Invitation to Tender (ITT)
Main Entrance/Colonnade Glazing/Roof Replacement
Reference #: NGC110697
Buy and Sell Reference #: PW-17-00789081
September 6, 2017

ADDENDA # 1

Tender Addendum #1

Temporary Works Phase 3 – Colonnade and Main Entrance
window and roof replacements

1197A-21'C'

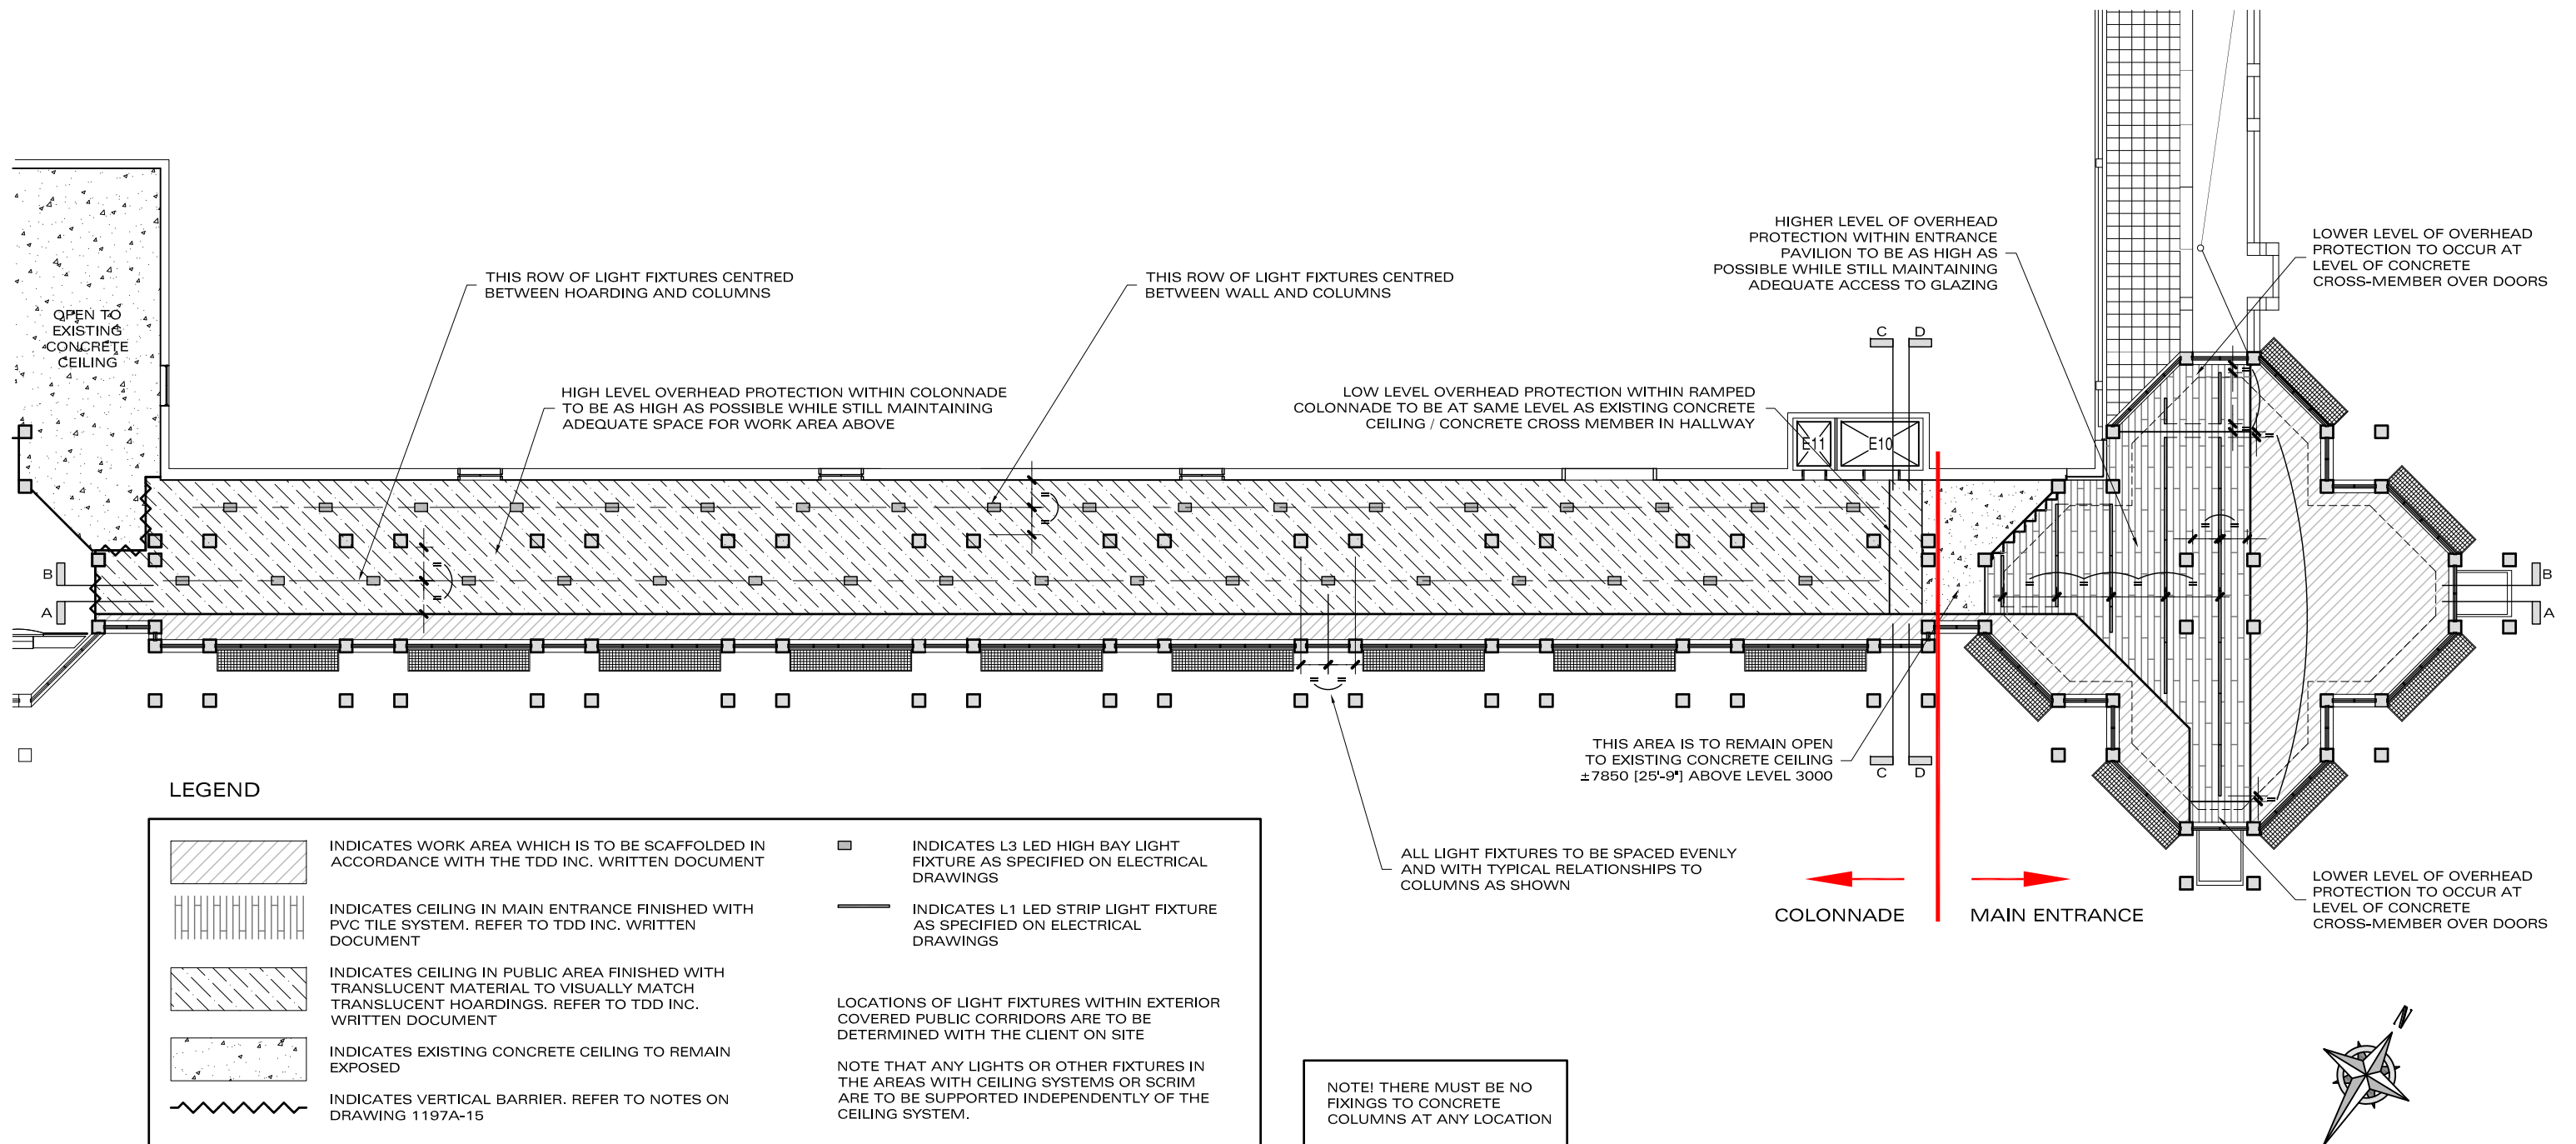
1. TDD Inc drawing 1197-21'C' (attached)
2. The south-west covered public corridor for emergency exiting (as shown below) is to be excluded from the aesthetic requirements of section 2.1.4. in the TDD Inc General Design Requirements document. This corridor shall be used for emergency exiting purposes only and is permitted to be separated from the adjacent construction zone with exposed construction fencing or similar, ie no plywood hoarding is required. All structural requirements for overhead protection still apply.
